## Service Kit

**Title:** Bell 429 Air Conditioner Condenser Blower Motor Upgrade

**Applicability:** Bell Helicopter Model 429 Equipped with the Air Comm Corporation 429EC-200 and -202 Air Conditioning Systems

Figure 2. High performance blower on the condenser assembly

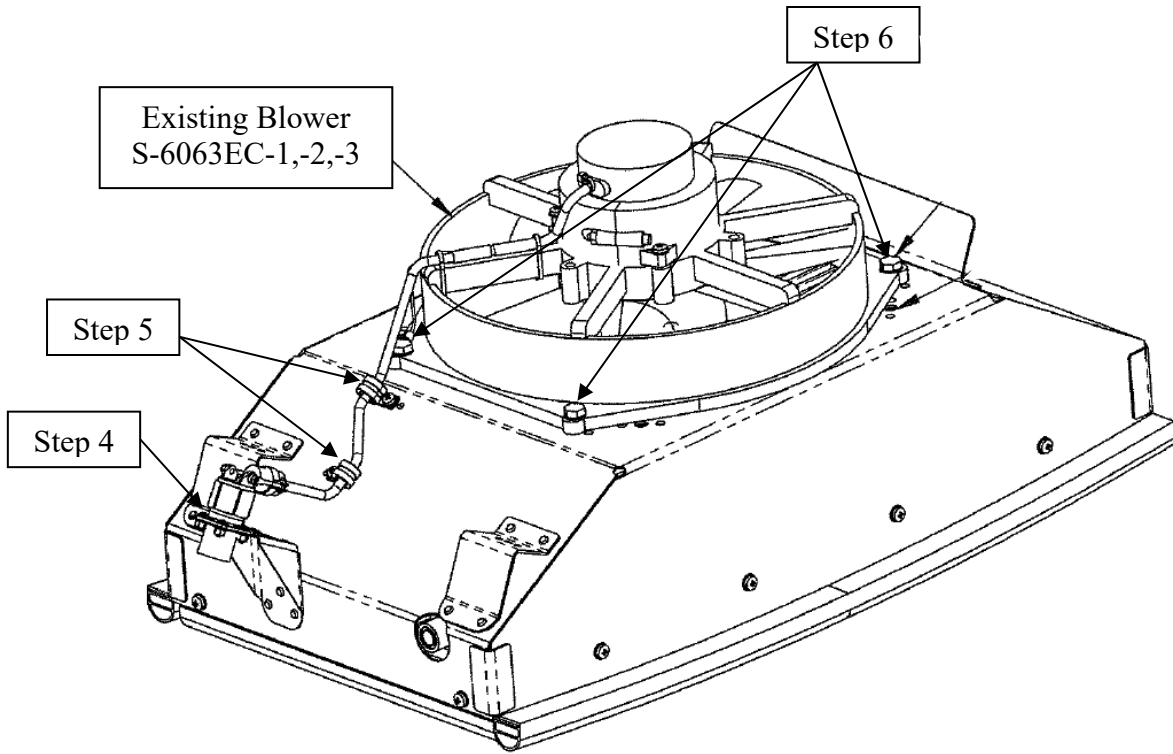
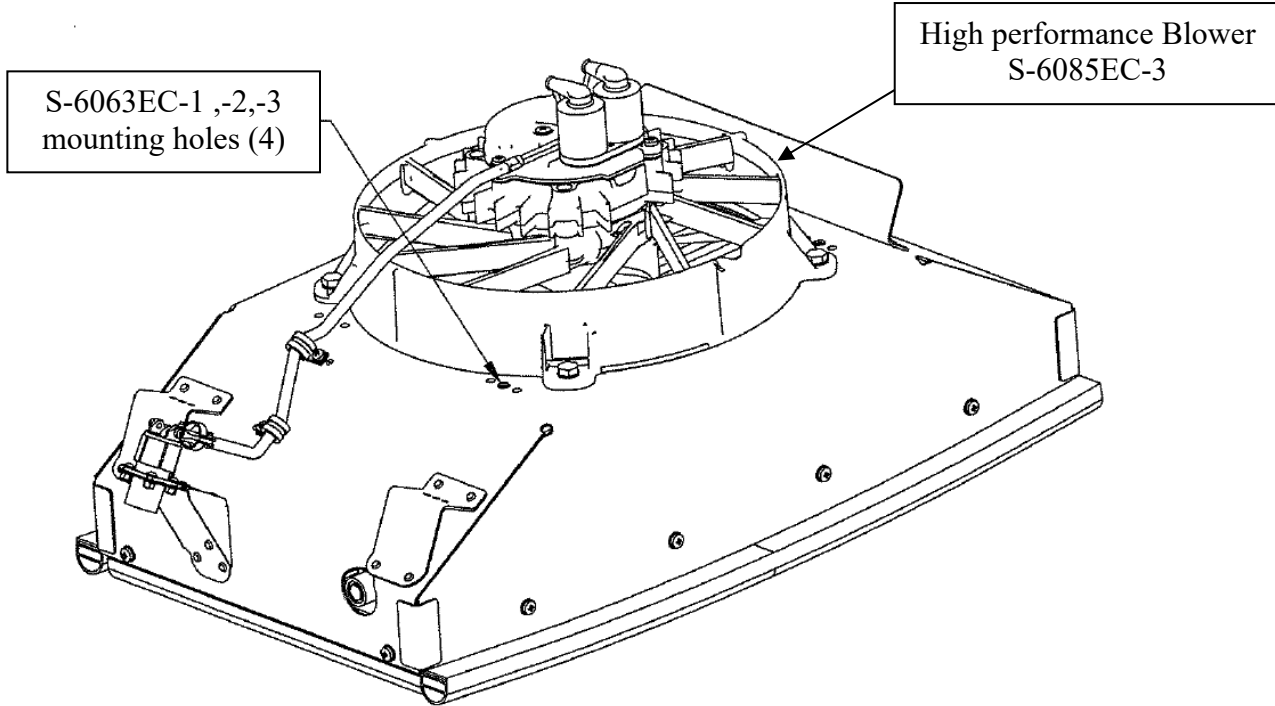
This document provides for an air conditioning system improvement for aircraft operating in extreme environments by the replacement of the existing condenser blower with a blower that provides a higher condenser performance. This document also provides information for modifying the supporting electrical wiring to accommodate the slightly higher power draw of the new blower.

1. If the S-6085EC-3 condenser blower assembly mounting holes are not pre-existing in the condenser housing, locate the new mounting holes using the new S-6085EC-3 condenser blower assembly as a template by centering it over the existing blower opening in the condenser housing and transferring the holes.
  - a. Install 4 each MS21059L5 nutplates using 8 each MS20426AD4-5 Rivets.
2. Remove any RTV from the mounting holes if present.
3. Fit the condenser blower into place.

Figure 3. Circuit Breaker panel and Air Conditioning Relay Panel Box

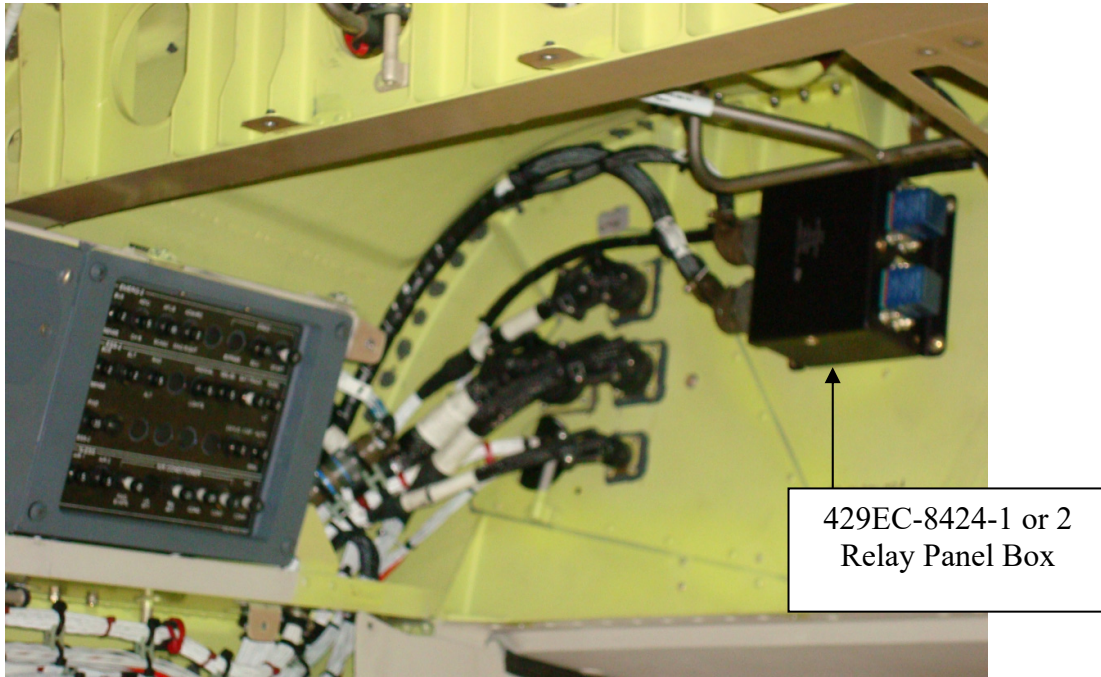
1. Remove 1 each MS26574-20 20 AMP circuit breaker located at the "COND" position in the RH Non Essential Bus.

1. Install 1 each MS26574-25 25 AMP circuit breaker at the "COND" location in the RH Non-Essential Bus.

Figure 5. 429EC-8424EC-1 Relay Panel Box Wiring, existing and modified

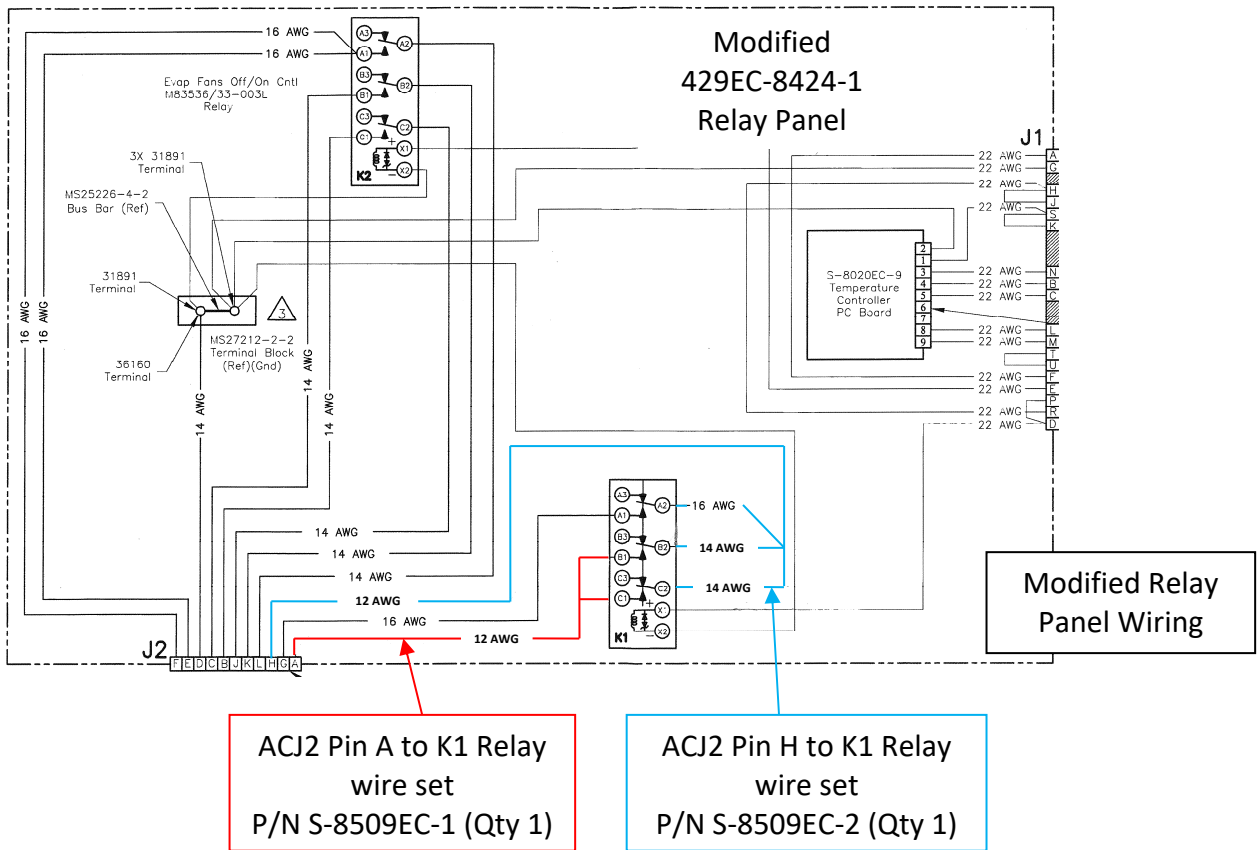
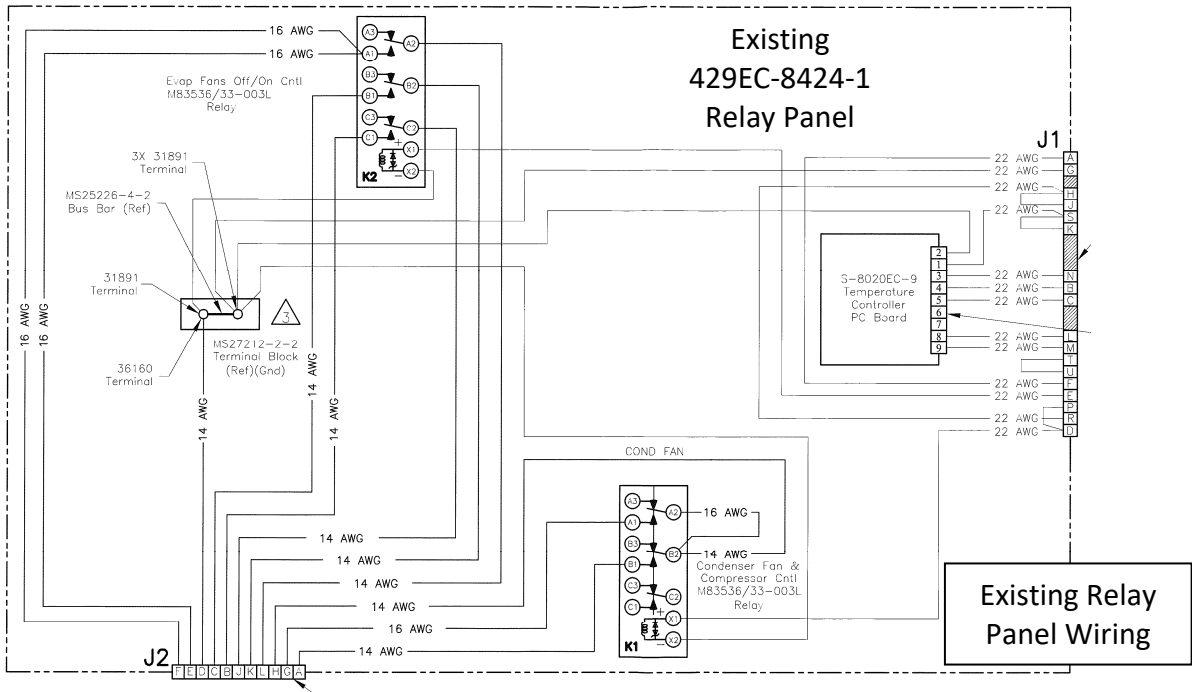
1. Locate the 429EC-8424-1 Relay Panel Box. Disconnect the external connections and remove the box.
2. Referring to electrical schematic Figure 5, remove wire between Pin A at the ACJ2 receptacle and pin B1 at the K1 relay.
3. Remove wire between Pin H at the ACJ2 receptacle and pins A2 & B2 at the K1 relay.

1. Install 1 each supplied S-8509EC-1 wire set between Pin A at the ACJ2 receptacle and pins B1 & C1 at the K1 relay.

2. Install 1 each supplied S-8509EC-2 wire set between Pin H at the ACJ2 receptacle and pins A2, B2 & C2 at the K1 relay. Note that the smaller, 16 ga wire must be inserted into position A2 on K1 and the 14 ga wires must be inserted into B2 & C2.
3. Replace the 429EC-8424-1 Relay Panel Box and re-mate the electrical connections.
4. Apply aircraft electrical power and verify operation of the condenser blower.

Figure 6. 429EC-8424EC-2 Relay Panel Box Wiring, existing and modified

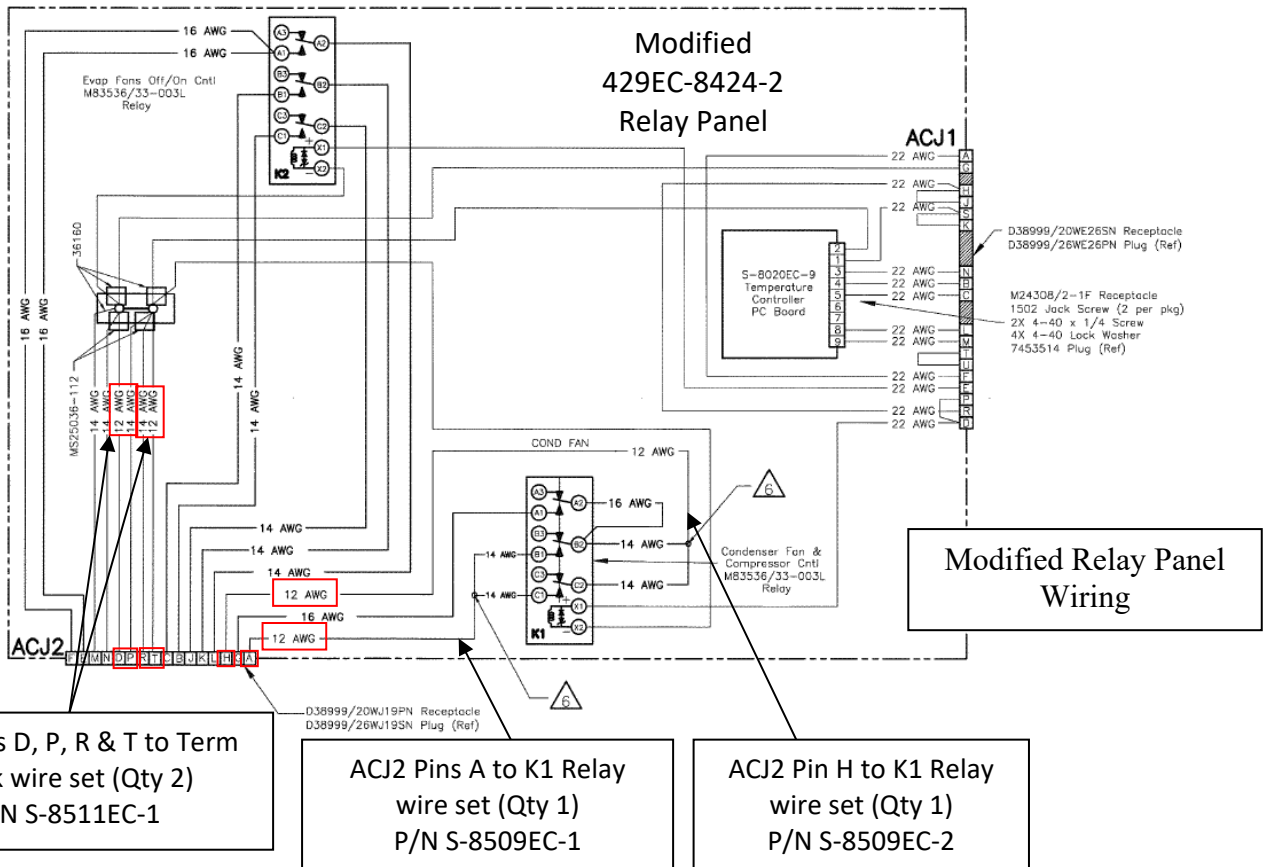
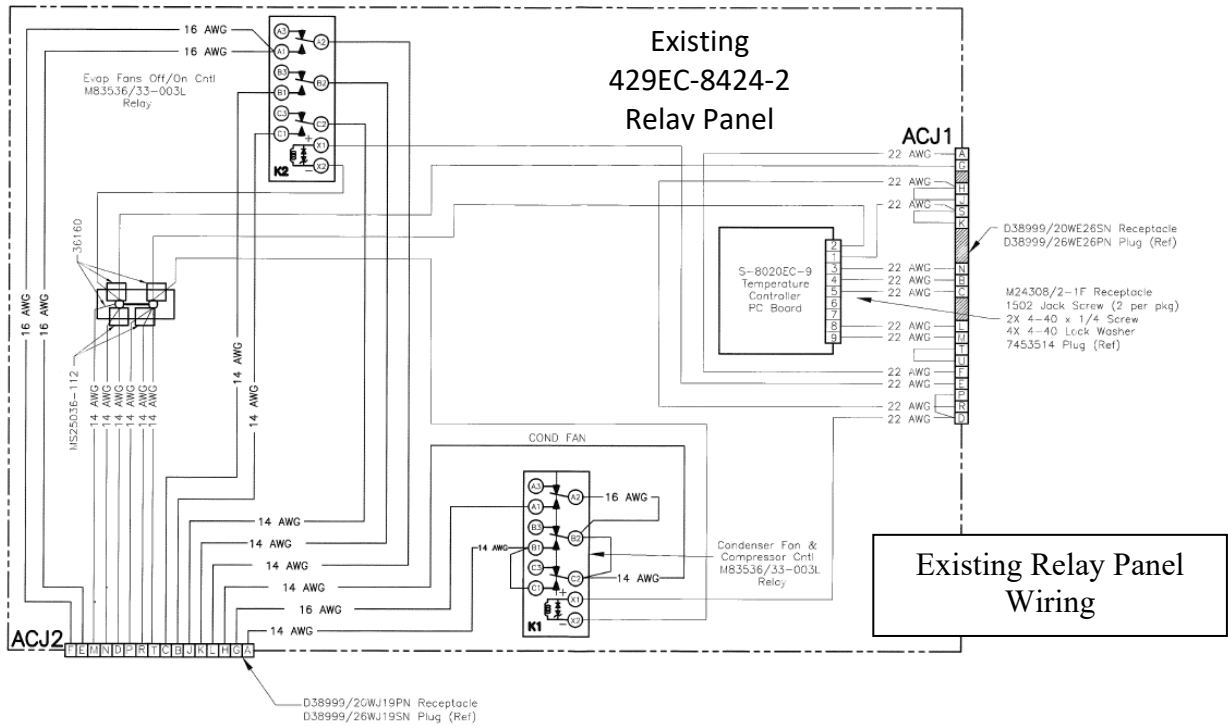
1. Locate the 429EC-8424-2 Relay Panel Box. Disconnect the external connections and remove the box.
2. Referring to electrical schematic Figure 5, remove wire between Pin A at the ACJ2 receptacle and pins B1 & C1 at the K1 relay.
3. Remove wire between Pin H at the ACJ2 receptacle and pins B2 & C2 at the K1 relay.
4. Remove wire set from ACJ2 pins D & P and the terminal block.
5. Remove wire set from ACJ2 pins R & T and the terminal block.

1. Install 1 each supplied S-8509EC-1 wire set between Pin A at the ACJ2 receptacle and pins B1 & C1 at the K1 relay.
2. Install 1 each supplied S-8509EC-1 wire set between Pin H at the ACJ2 receptacle and pins B2 & C2 at the K1 relay.
3. Install 1 each supplied S-8511EC-1 wire set from ACJ2 pins D & P receptacle and the terminal block. Note that pin D receives the 12 ga. wire, and pin P receives the 14 ga. wire.
4. Install 1 each supplied S-8511EC-1 wire set from ACJ2 pins R & T receptacle and the terminal block. Note that pin T receives the 12 ga. wire, and pin R receives the 14 ga. wire.
5. Replace the 429EC-8424-2 Relay Panel Box and re-mate the electrical connections.
6. Apply aircraft electrical power and verify operation of the condenser blower.
